# ILC Interaction Region Configuration Change Request

LCWS14, Belgrade  
Karsten Buesser  
07.10.2014

## **DETECTOR HALL WITH VERTICAL SHAFT ACCESS**

# Outline of the Detector Hall (D/H) construction procedure

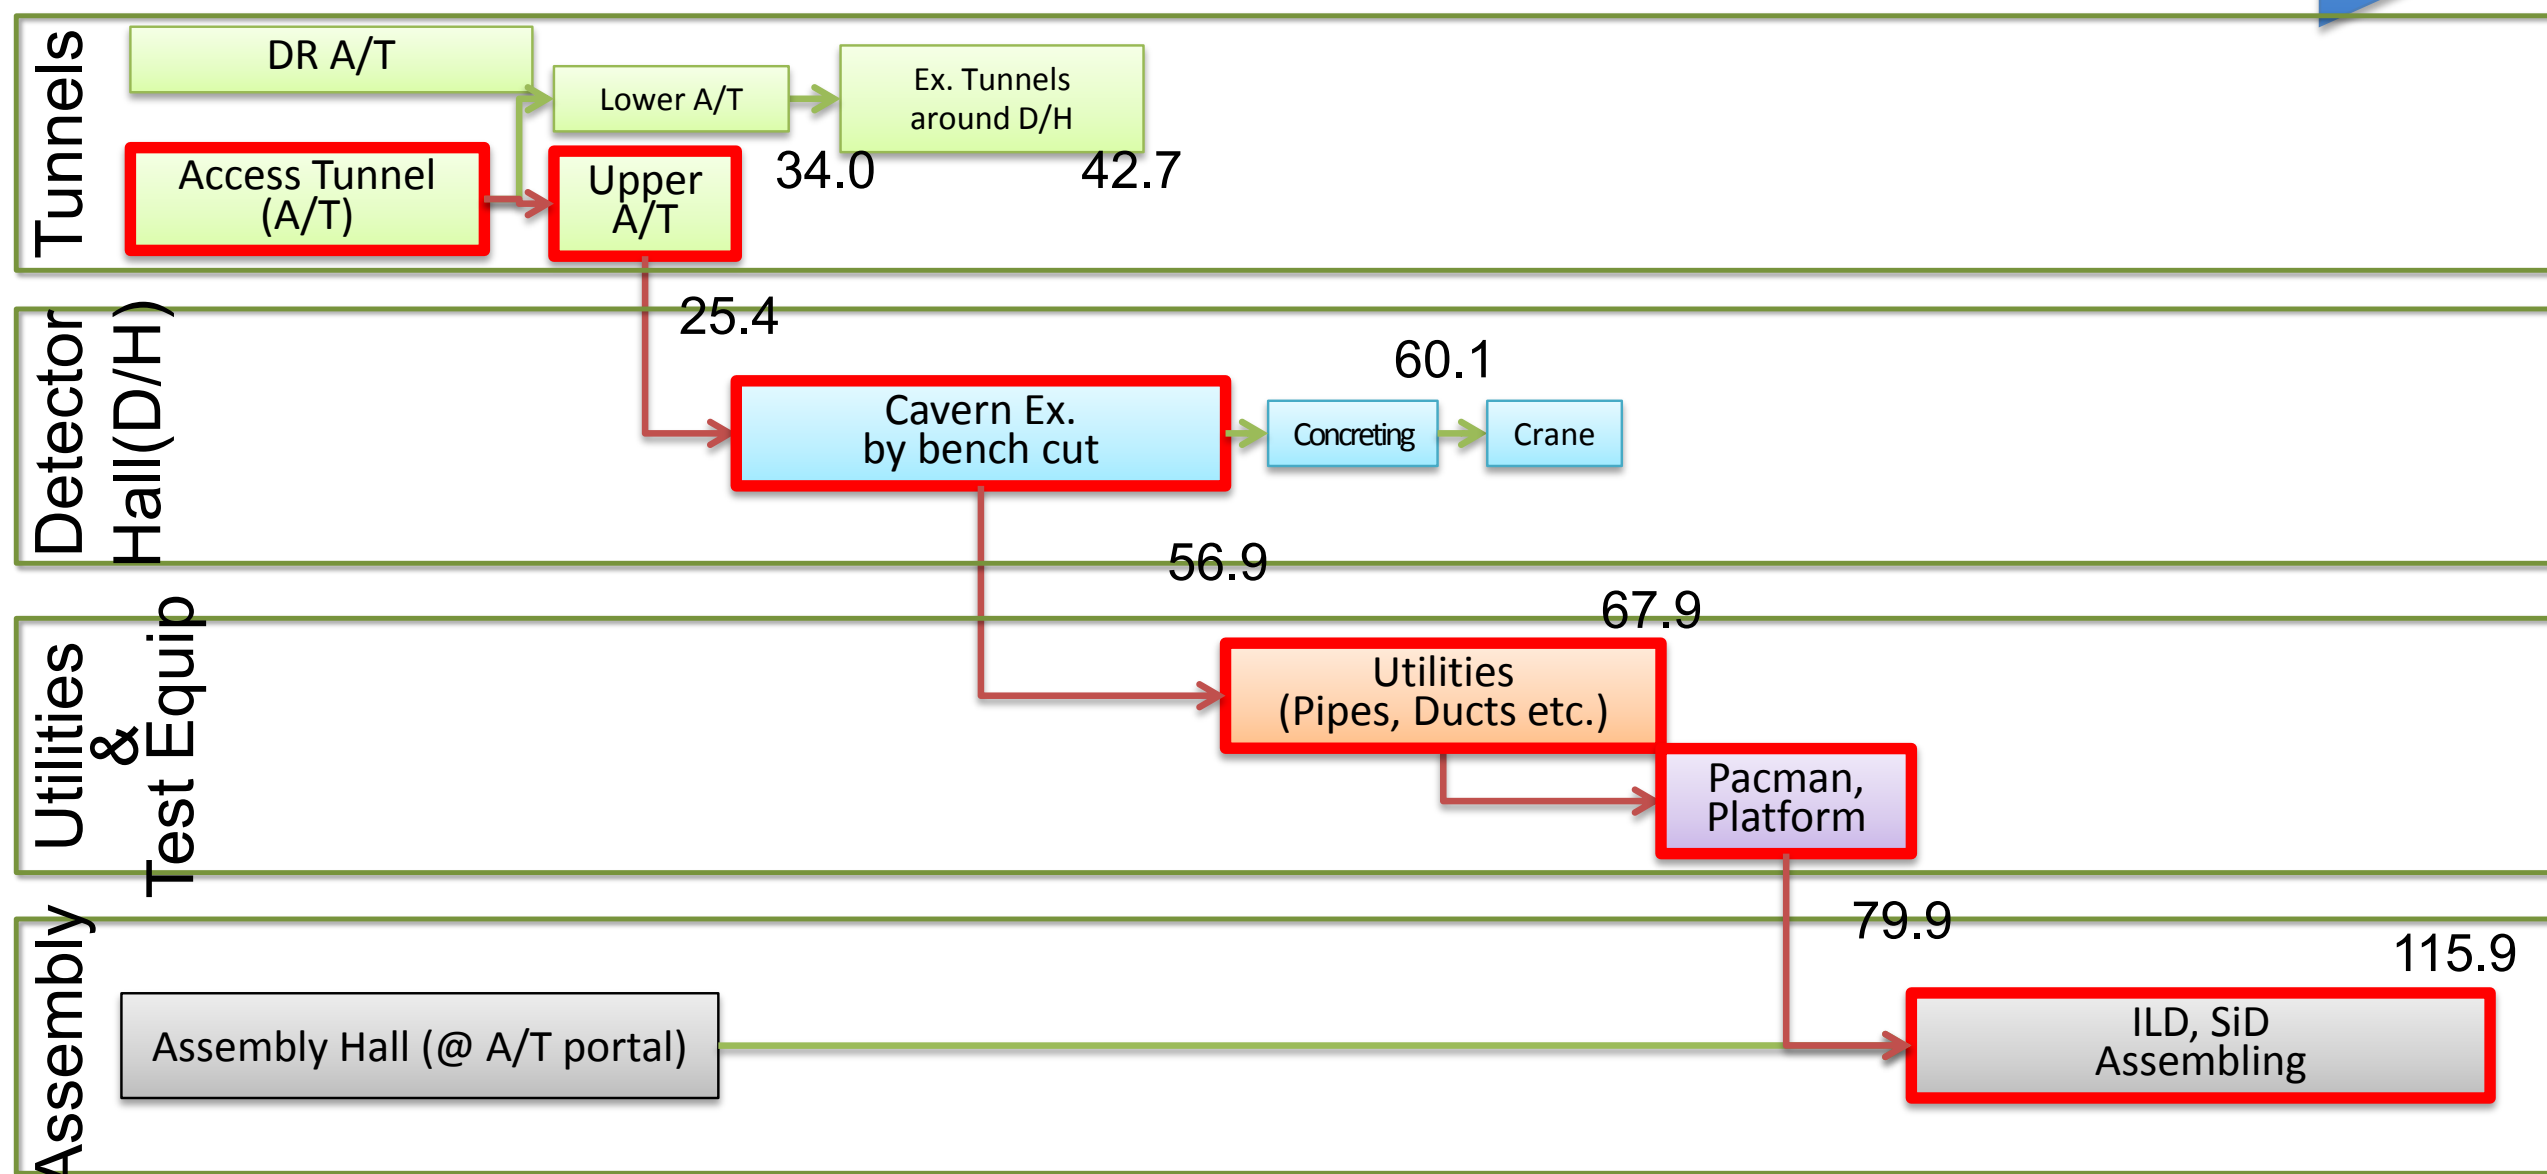
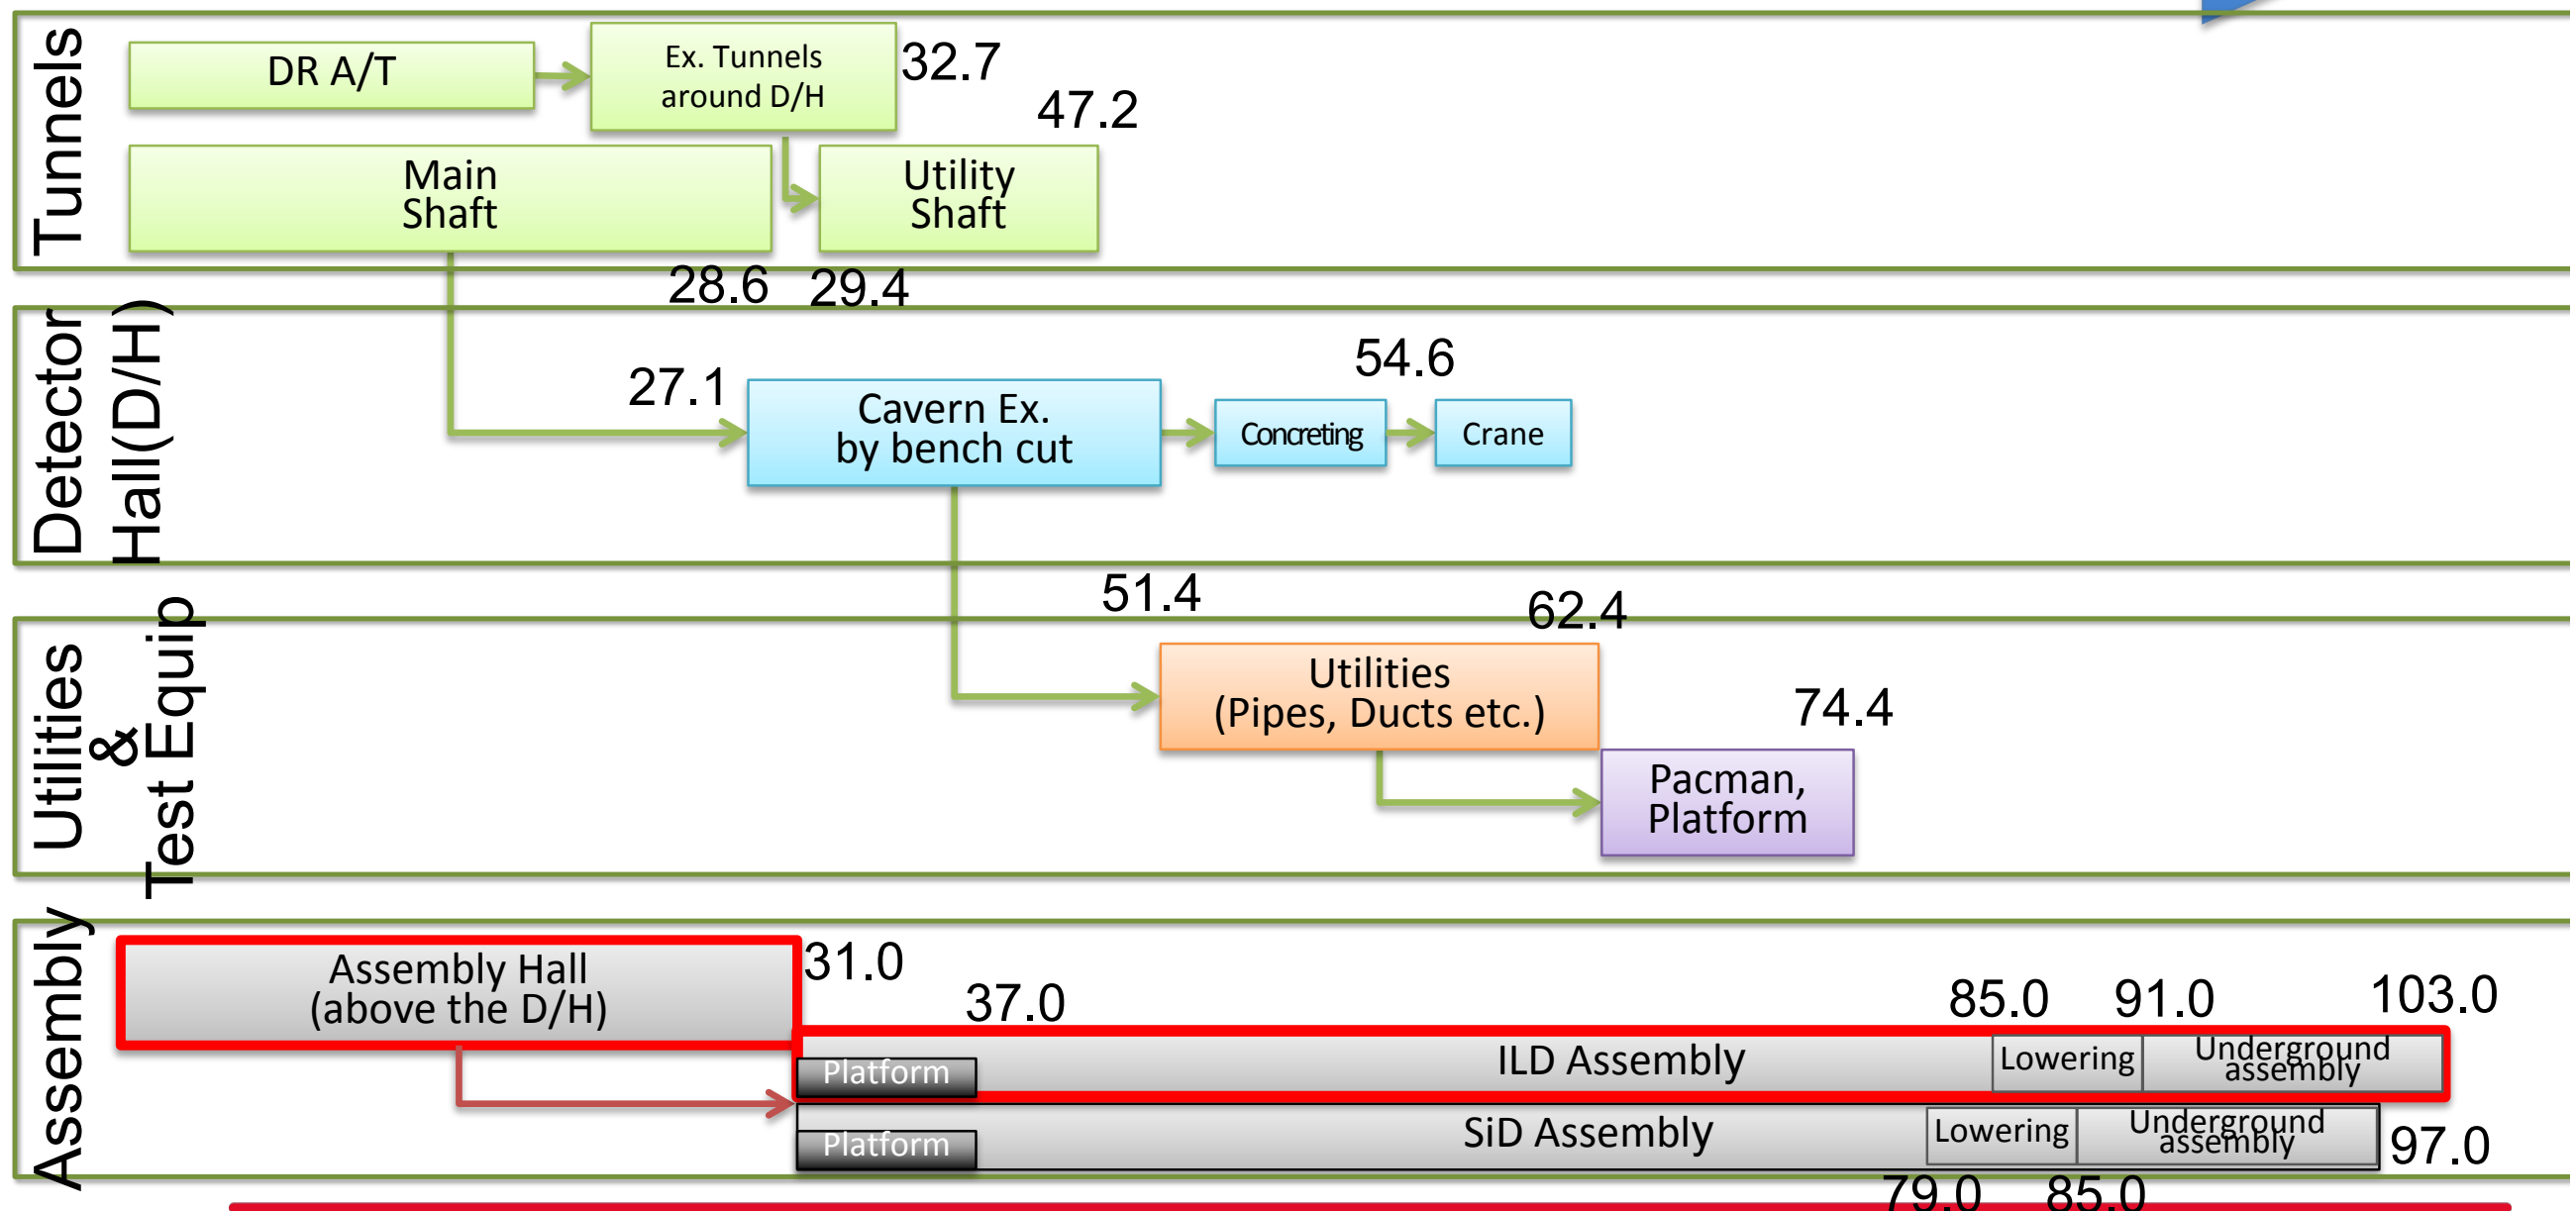
Time-line (const. period: 115.9 months)

Time-line (const. period: 103.0 months)
